Decision Report

Application for Works Approval

Works Approval Number W6280/2019/1

Premises Nickel West Leinster Nickel Operations
Tenements ML255SA, M36/230, L36/93, M36/4, M36/389,
G36/49 and G36/50

Figure 2: Prescribed Premises boundary

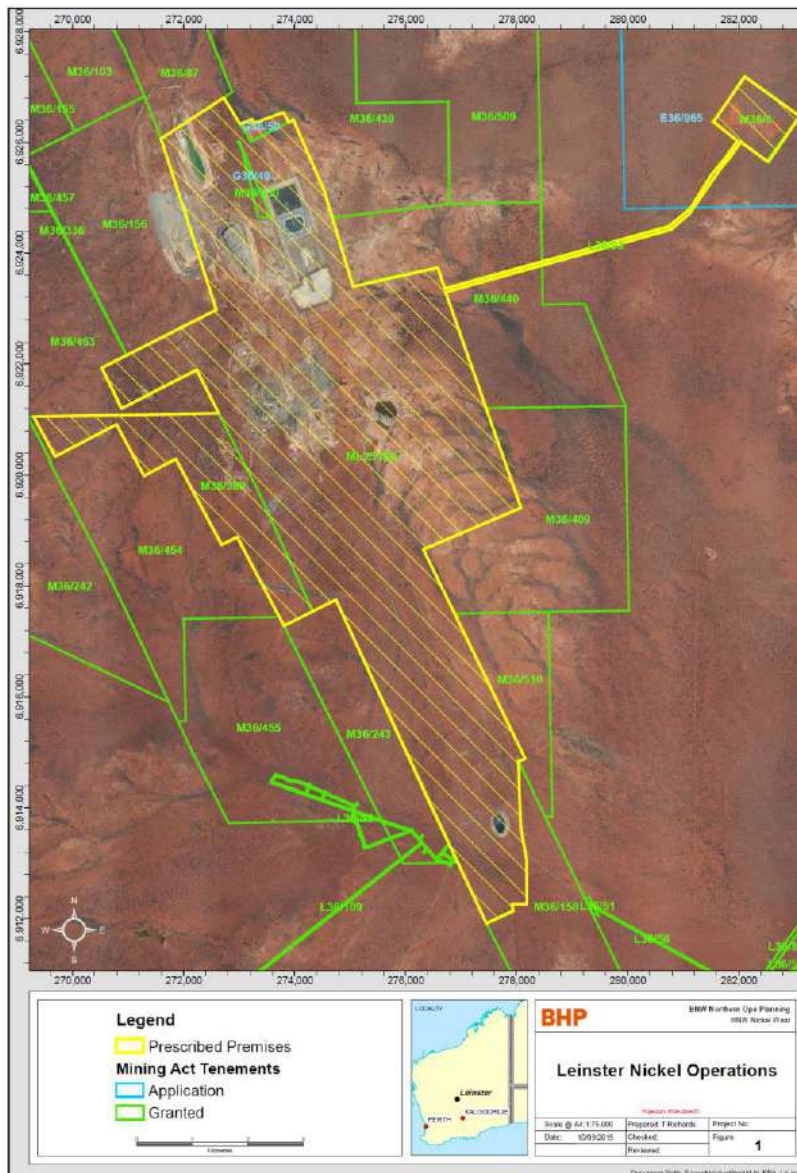
Condition ¹	Summary of Licence Holder comment	DWER response
	Requested 'lined with 2mm thick HDPE geomembrane' changed to 'lined with 2mm thick HDPE geomembrane <u>or equivalent</u> . Return water pond to be operational prior to the decommissioning of the existing return water pond to the north of TSF3 Cell AB.'	'lined with <u>at least</u> 2mm thick HDPE geomembrane' (discussed with Stacey Cook 26/11/19; wanted flexibility to go thicker if required) - Second sentence added as requested
	Requested final crest height changed from 10537.8m to 10540m.	Elaborated to give flexibility for final stages, as per design report A1812146. Does not change the risk assessment. 'Stage 8 will either be a 2.8m raise giving a final crest height of RL 10537.8m; or two 2.5m raises giving a final crest height of RL 10540m.'
Figure 2	- Caption: Clarified 'Cell F' to 'TSF 3 Cell F' - Updated Figure 2 provided showing newly granted general purpose leases	Changes accepted
